April 4, 2025

Re: Kitty Duvall Drive-Parcel 109
Variance Application submittal
3260 Kitty Duvall Drive
Annapolis, MD. 21403
Tax Map 57, Grid 14, Parcel 109

DEVELOPED CONDITIONS VARIANCE PLAN
KITTY DUVALL ~ PARCEL 109
3250 KITTY DUVALL DRIVE, ANNAPOLIS, MARYLAND 21403
TAX MAP 57 GRID 14 PARCEL 109 DISTRICT 2ND
TAX ACCT. NO. 02-000-65037200
ANNE ARUNDEL COUNTY, MARYLAND

CONFIRMATION OF PRE-FILE (2025-0020-P)

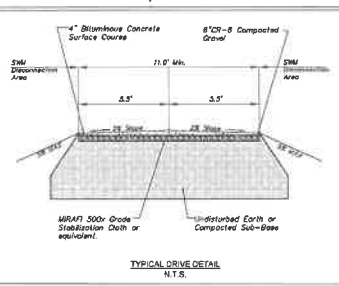
Please verify the locations of all of the slopes 15% or greater. There are areas that appear to have been missed.

Please correct the legend as the symbols do not coincide with those used on the plan.

The steep slopes are not shown on the site plan depicting the proposed development so a complete evaluation cannot be completed. The layout and design of the structure however were not developed to avoid the steep slopes and in fact push the home further into the slopes. While it is recognized that the site is encumbered by environmental features, the home should be designed to avoid those features as much as possible.

1. On Sheet 1 of 2, for all structures, clearly label which structures are to remain and which are to be removed.
2. The Existing 15% Steep Slopes layer's hatch disappears when zoomed in, making it difficult to review the plans.

3. The steep slope buffer needs to extend not just along the eastern side (top) of the steep slopes but along the northern and southern portions. This would make the northernmost micro-bioretenion location within the steep slope buffer. SWMs cannot be installed within the steep slope buffers. They also cannot be installed within the 100-foot buffer.

4. Geothermal wells must have a 30-foot setback from a building's foundation. They are to also have a 15-foot setback from the 10' Ingress/Egress easement.

5. Geothermal wells need to be 50 feet from any source of contamination. Note where, if any, above-ground or below-ground propane tanks are present on the site and neighboring properties.

6. Per the Letter of Explanation, "the scope of the project will propose an 8" Sewer Main Extension with a standard cleanout." Expand the limits of disturbance to include the installation of the sewer main extension. At Grading Permit, a public utility easement and a Public Works Agreement will need to be required.

7. The LOD to the north of the easternmost micro-bioretenion is within the Kitty Duvall Drive ROW.
8. The easternmost micro-bioretenion must be 10 feet from the property line.

9. It appears there is plenty of open upland land allowing the house to be pulled out of the steep slope. This will be deferred to OPZ's Critical Area Team reviewer and/or OPZ's Zoning Administrator reviewer.

11. Label the contours correctly. Along the northern portion of the site the 6' contour is labeled as 9'.
12. At Grading Permit, the 10' Ingress/Egress easement will need to be expanded to include the neighbor's (3264/3266 Kitty Duvall Drive) existing driveway located on the property.
13. At Grading Permit, if the existing telephone and cable pedestals are not covered with an existing easement on the property, an easement(s) will be needed.

A **Pre-File** confirmation and recommendation was addressed by the Office of Planning and Zoning including input from Inspections and Permits. To clarify, the 15% and greater steep slopes have been accurately illustrated based on field run topographic survey. The existing steep slopes are delineated per the Critical Area Overlay criteria which defines steep slopes that are contiguous and a minimum 6-feet vertical. In addition, the height of the structure has been corrected to 35-feet.

STEELE RESIDENCE
PROPOSED ELEVATIONS

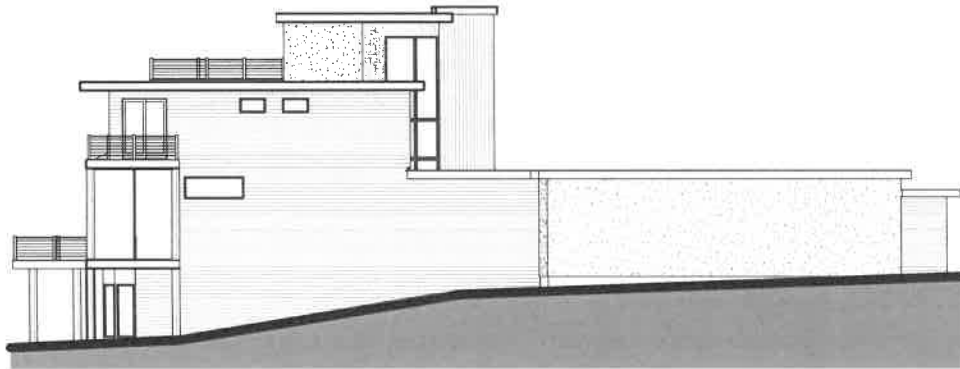
The **Zoning Administration Section** advises that the proposed dwelling height of 40' is greater than the 35' allowed for principal structures in the R2 District. The height will need to be revised or the applicant will need to seek a variance to the height requirements. The proposed development is expansive and the applicant should explore ways to reduce the improvements and therefore reduce the impacts to steep slopes. The dwelling, porch, garage and patio alone have a footprint over 5,000 square feet. The applicant has provided no justification for how the development as a whole meets the criteria of the minimum variance necessary to afford relief.
